## **Main Injector Electronics**

### **Electrical Schematic of the Beam Position Monitor Transition Board Control Module**

**Document # Beam-doc-2154-v1**

MI BPM TB Control Module HARDWARE CHANGES

**BACKPLANE**

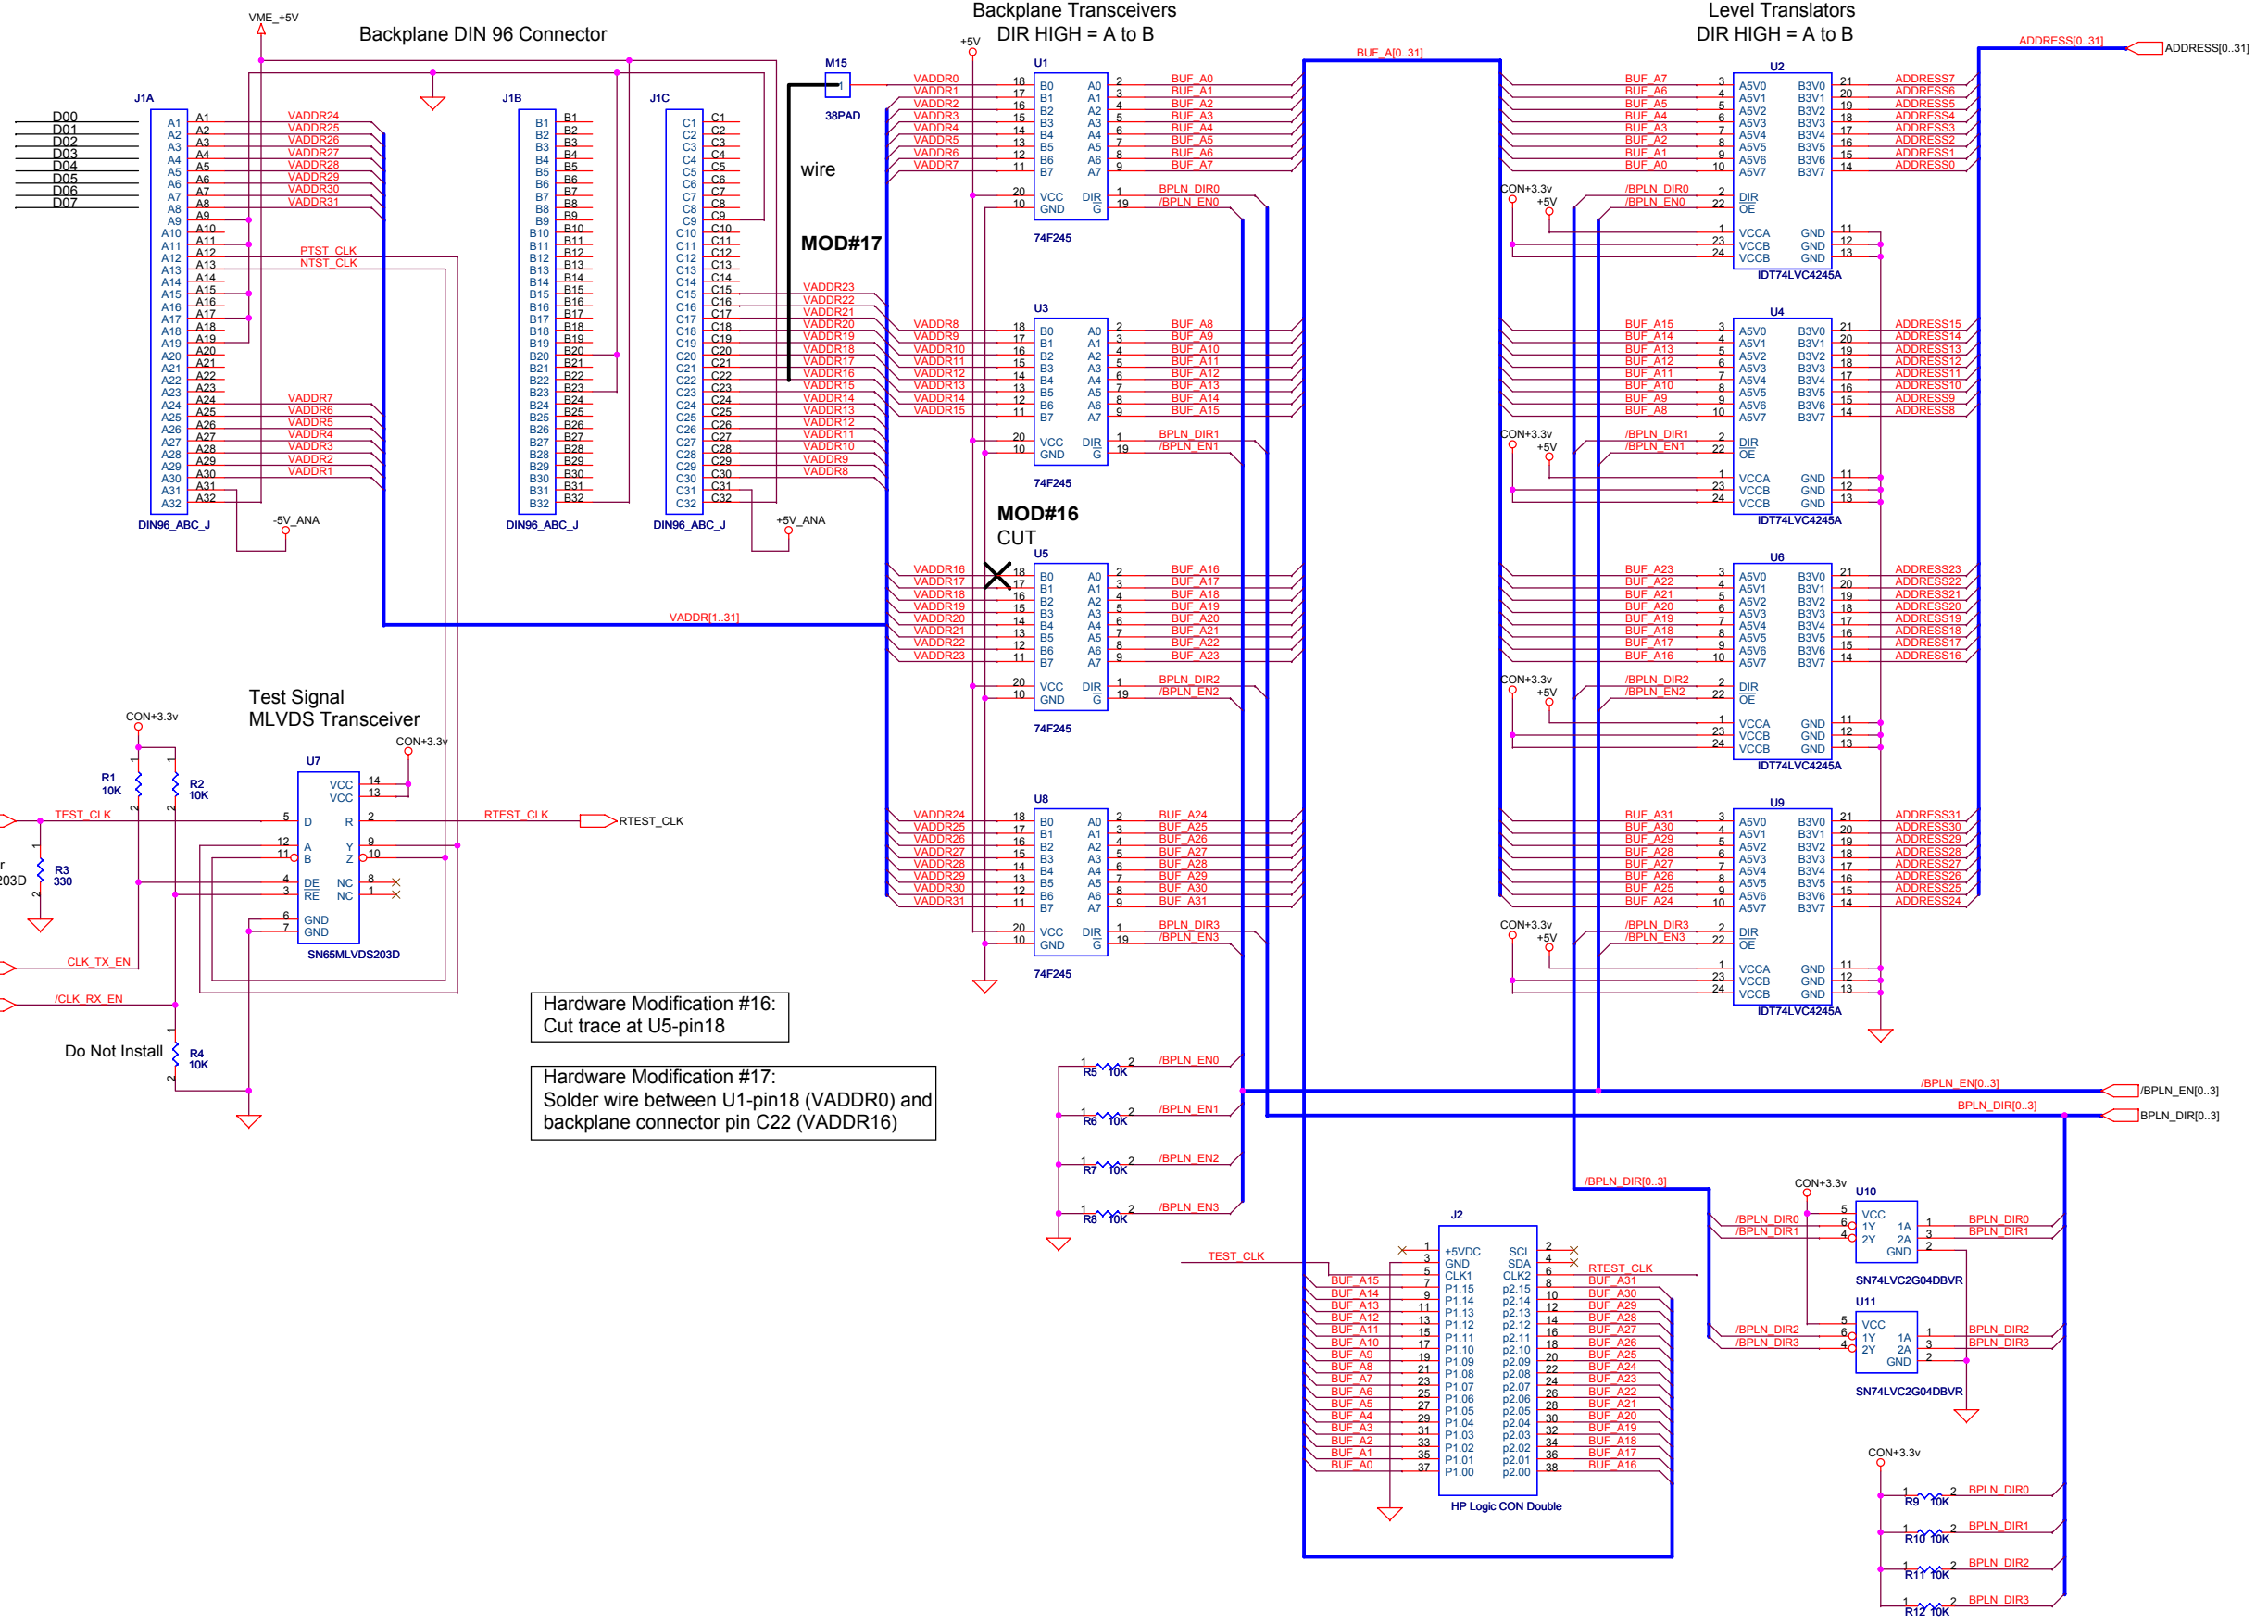
Hardware Modification #16:  
Cut trace at U5-pin18

Hardware Modification #17:  
Solder wire between U1-pin18 (VADDR0) and  
backplane connector pin C22 (VADDR16)

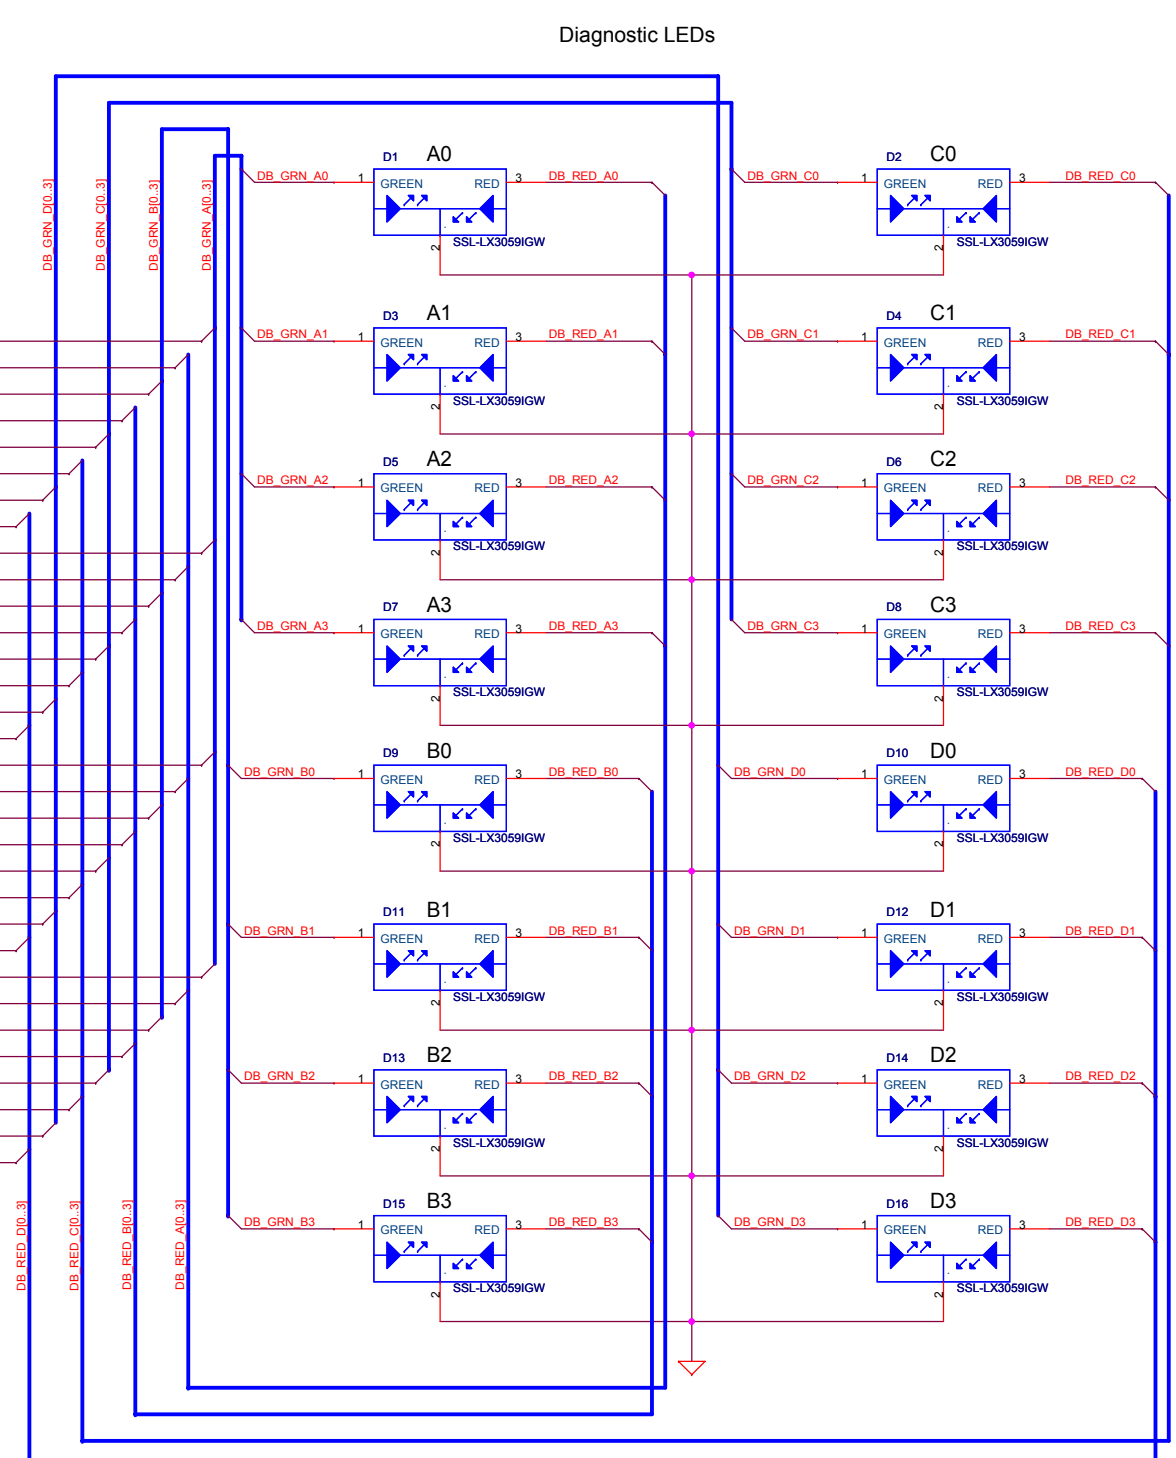
**Hardware Modification #15:**  
Cut trace on the bottom of the board attached to pin16 of display daughterboard. Cut the trace on both sides of ground via shorting the trace. Remove R31. Jumper R31-pin2 to R33-pin2.

Debounce and Power Sequencing

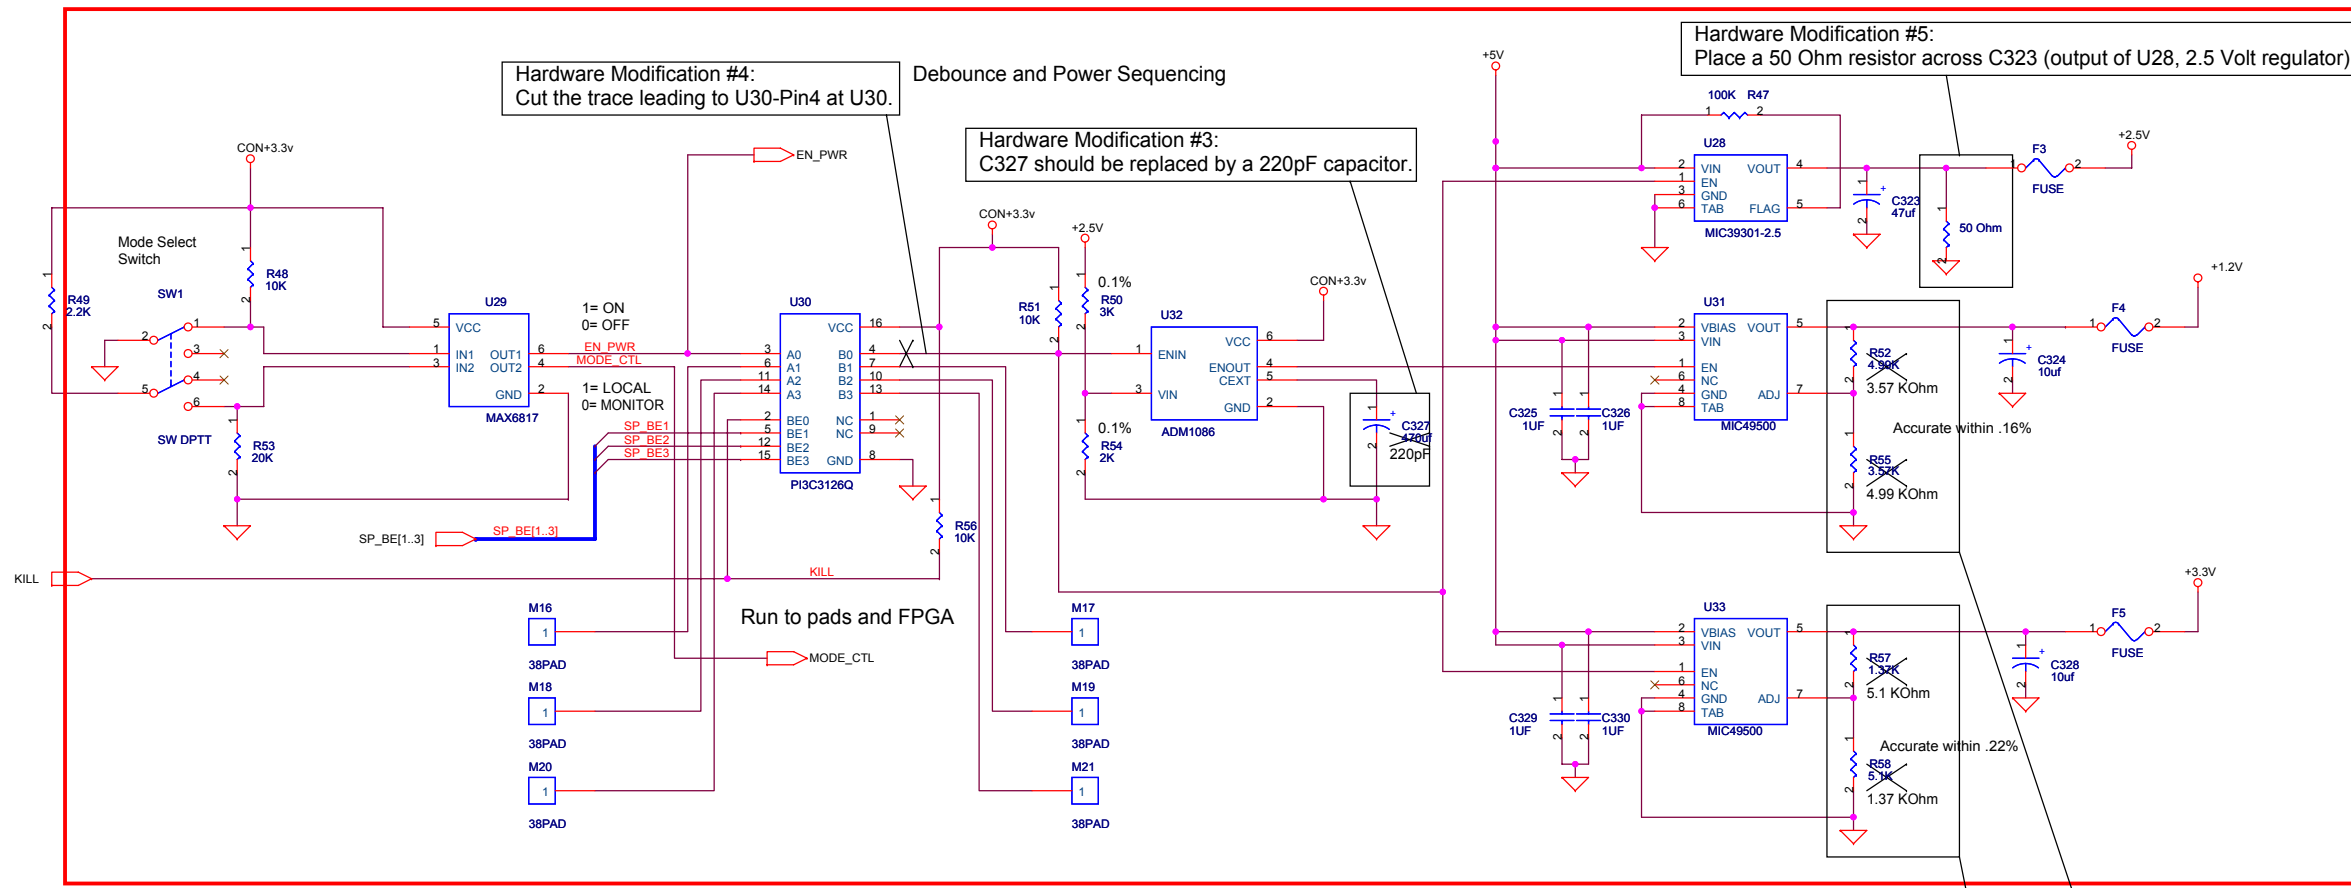
Hardware Modification #4:  
Cut the trace leading to U30-Pin4 at U30.

POWER

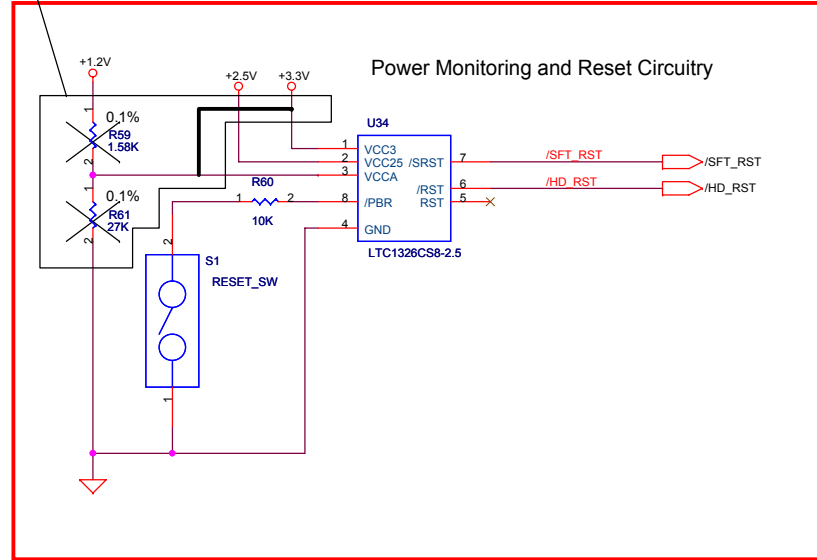
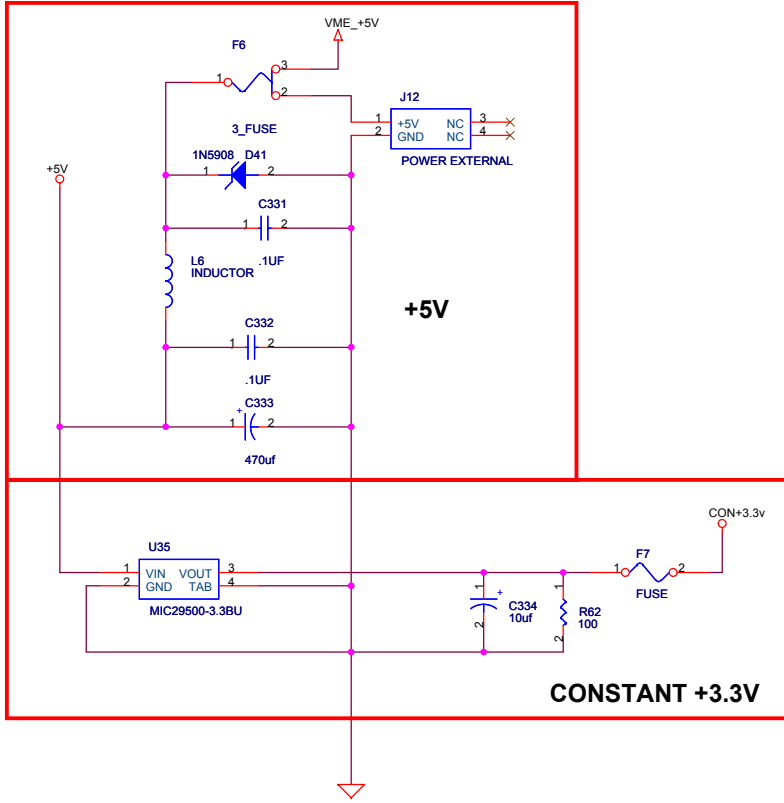
Hardware Modification #3:  
C327 should be replaced by a 220pF capacitor.

Hardware Modification #5:  
Place a 50 Ohm resistor across C323 (output of U28, 2.5 Volt regulator)

Hardware Modification #7:  
Reverse Resistors used to set output voltage of U33 (1.2 Volt regulator).  
R57 should be 5.1 KOhm (512). R58 Should be 1.37 KOhm (14H).

Hardware Modification #6:  
Reverse Resistors used to set output voltage of U31 (1.2 Volt regulator).  
R52 should be 3.57 KOhm (54H). R55 Should be 4.99 KOhm (68H).

Hardware Modification #2:  
If R59 and R61 are not available to not install either of them.  
Place a direct connection (wire) between U34-pin3 (VCCA) and U34-pin1 (VCC3).
